## D/DRC Case

1015 King Street

**DESIGN/DEVELOPMENT REVIEW COMMISSION**  
**DESIGN REVIEW DISTRICT**  
**HISTORIC AGENDA**  
**EVALUATION SHEET**  
Case # 8

**NATURE OF REQUEST:** Request Certificate of Design Approval for new construction

FRONT ELEVATION

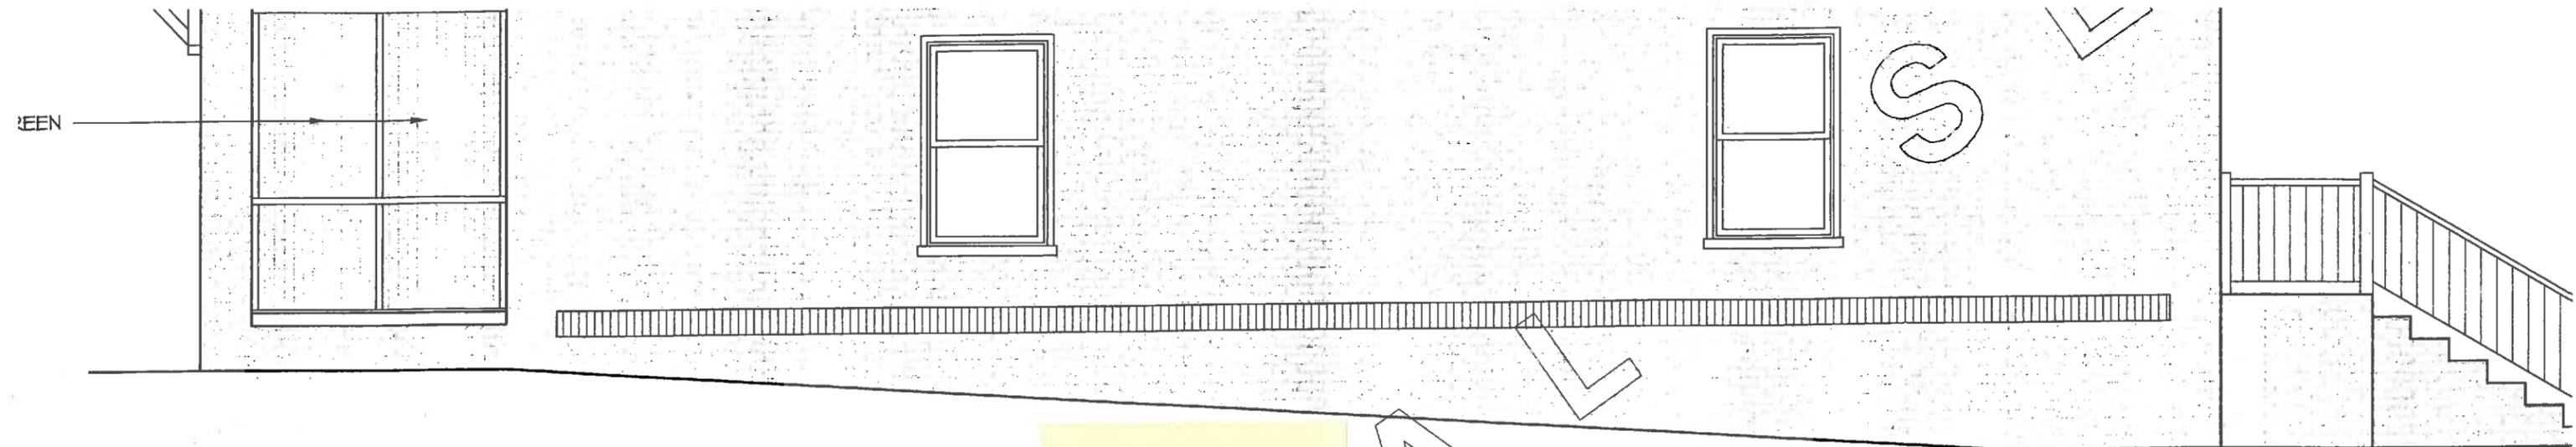
The façade is lacking any windows in the right bay, leaving about 15 feet of blank wall on the façade's right half. Although a screened porch is proposed for the right bay, screening is easily removable and depending on the screening, may be easy to see through. Therefore the right bay of the façade needs to have a window opening installed in order to meet this guideline.

Front Gable: There are wood brackets proposed as decorative items in the front gable; this detail matches what was on the house originally. Likewise there is a vent in the gable, similar to what is found in historic buildings. The proposed vinyl siding that mimics wood shakes in the gable is not like historic buildings nearby. This feature is inconsistent with nearby historic buildings and should be changed to either stucco or horizontal siding; staff can work out an alternative with the applicant.

Porch: The engaged front porch is supported by four brick columns, spaced similar to what was on the historic house at this site, but not quite the same. The middle and right bays created by the columns were equidistant in the original building with the left bay slightly smaller to emphasize the entry. The current configuration of the columns makes much more of the front façade visible and makes the rhythm of openings appear incongruent with historic buildings. In order to be more consistent with historic porch patterns, the third column from the left should be moved closer to the left to create more equidistant patterns. The right bay of the porch is going to be screened, which matches an alteration made to the original house. However, screening can easily be removed and should be considered a temporary change to any exterior.

- That the front gable be changed from a “wood shake” appearance to stucco or regular vinyl siding
- That a full size window be added to the front façade in the right bay
- That a window be added to the north elevation and that the window closest to the façade be moved closer and not more than 8 feet away from the front façade
- That the third porch column from the left be moved to the left to create equidistant central and right bays
- That driveway material and details be worked out with staff
- All details be deferred to staff

LEFT ELEVATION

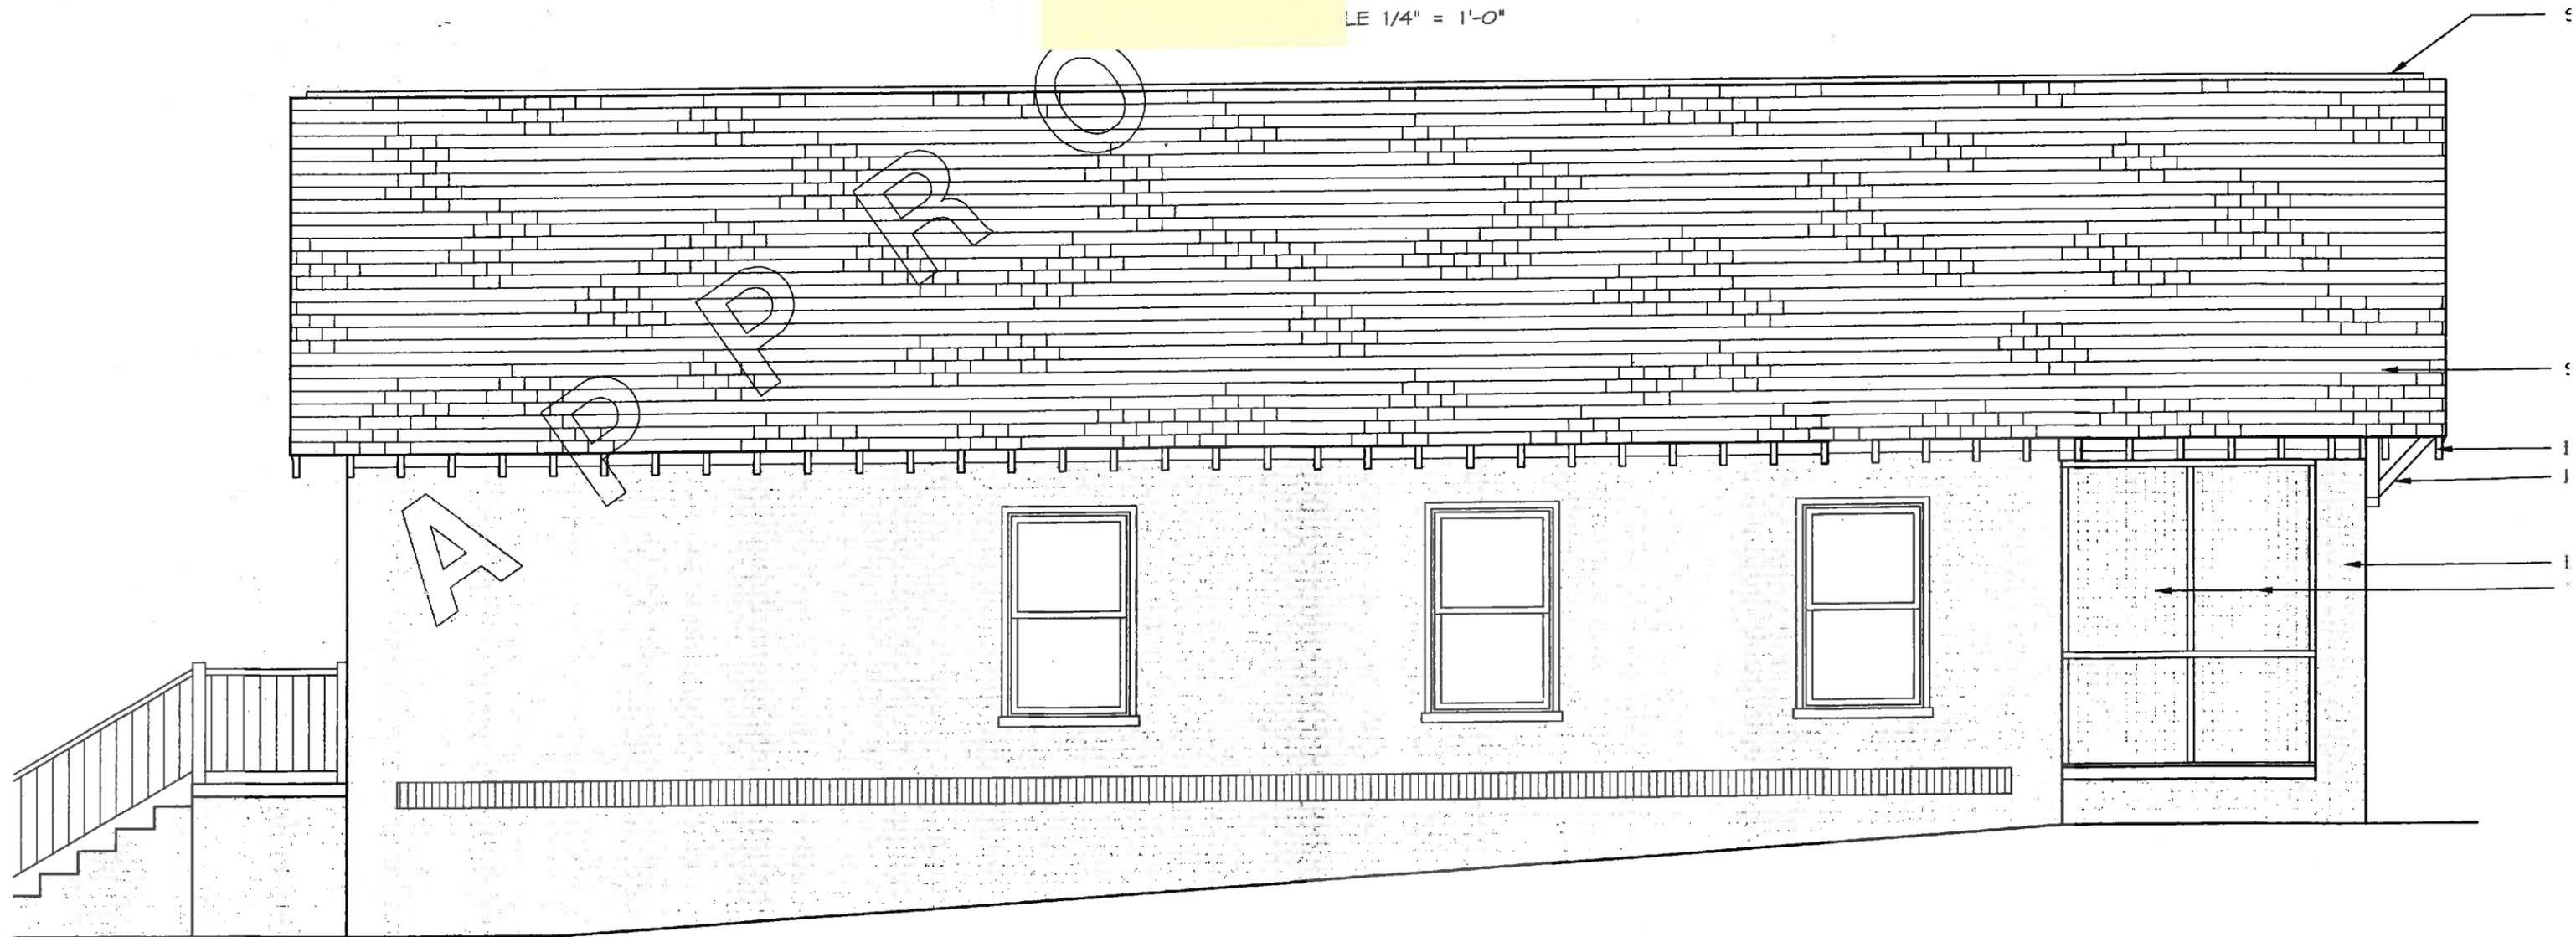
The left (south) side has an acceptable rhythm of openings, with windows that appear appropriately sized and spaced.

RIGHT ELEVATION

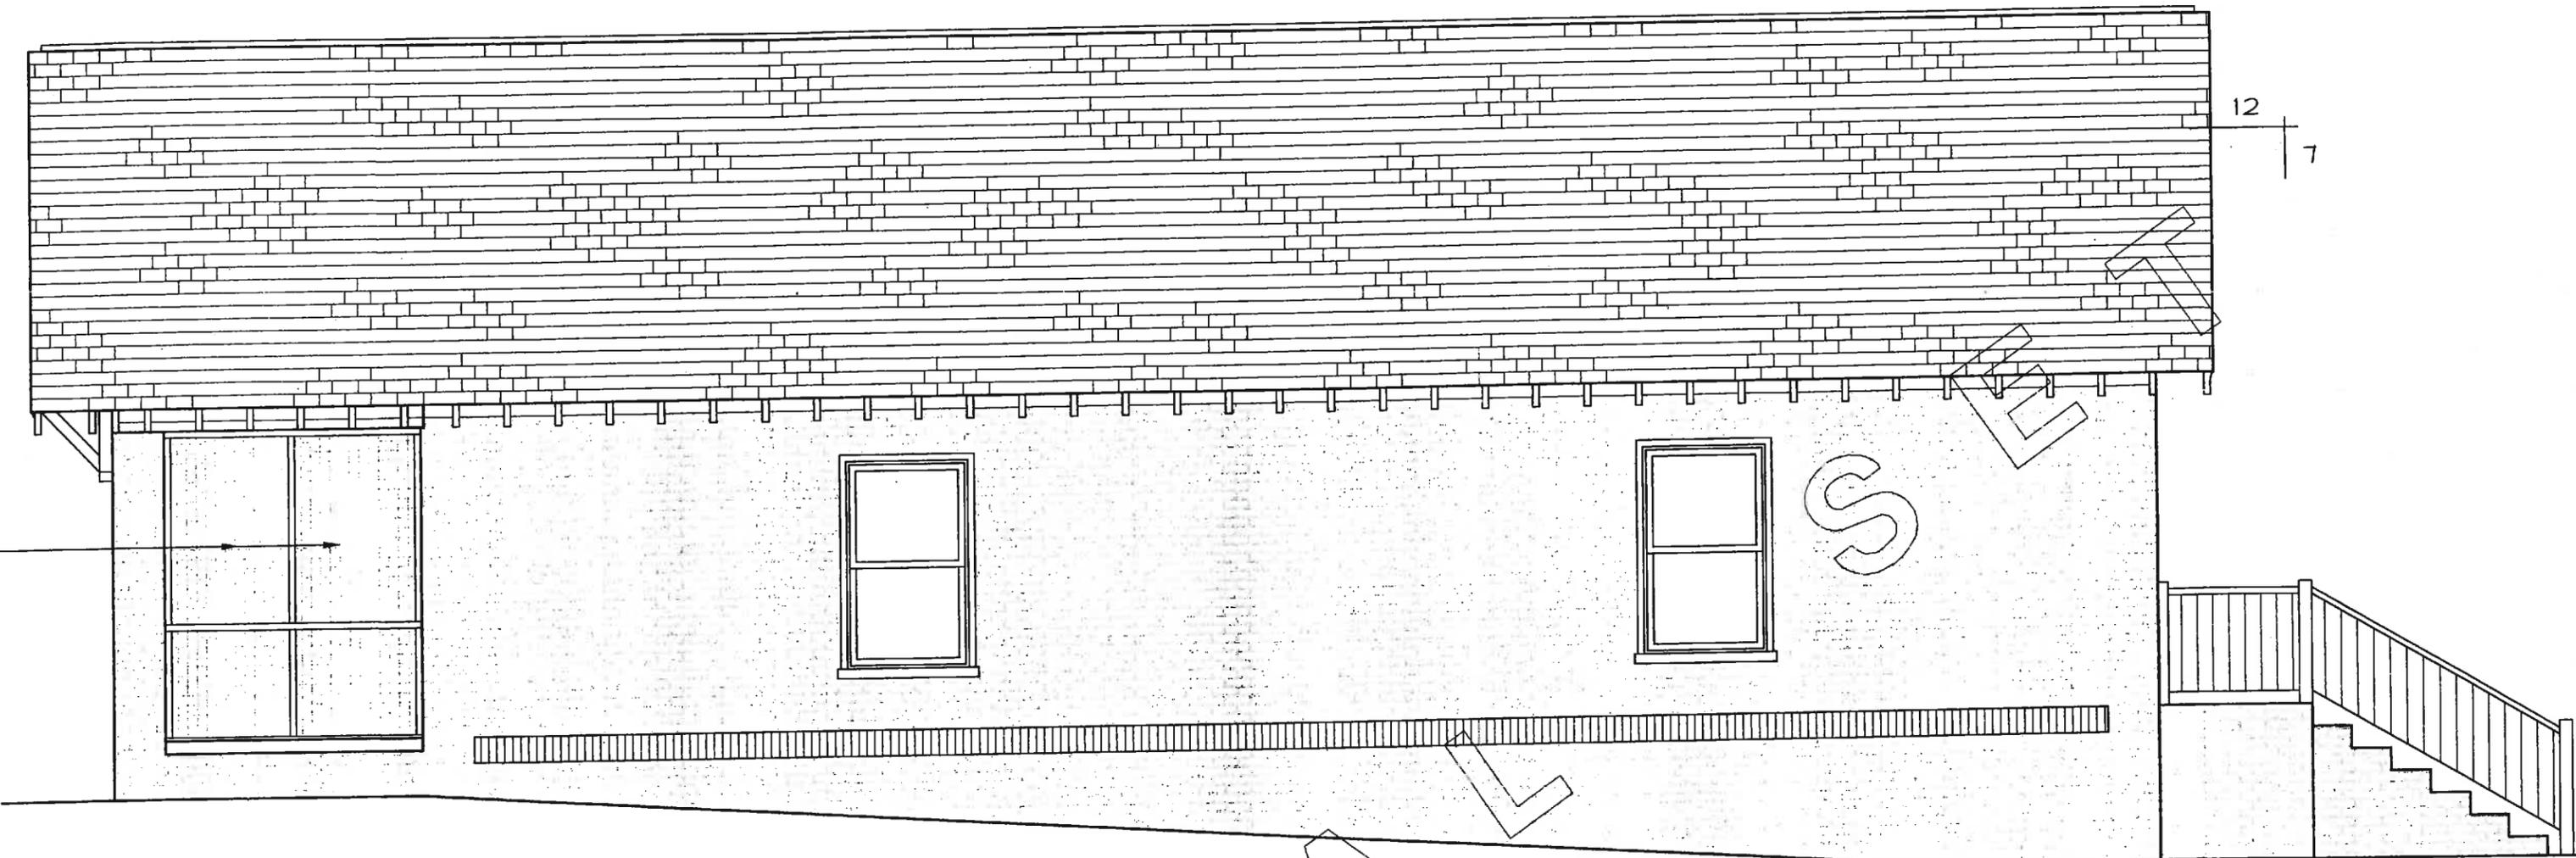
The right (north) elevation has only two openings, which is not consistent in pattern with historic buildings nearby, which all seem to have at least three window openings somewhat evenly spaced on side elevations. The window placement is also not consistent; there should be a window closer to the façade on this side. The current proposal has the first window twelve feet from the front corner, on center. Historic patterns have windows within two to six feet from the façade on side elevations. The rhythm of openings on this side needs to be altered in order to meet the guideline.
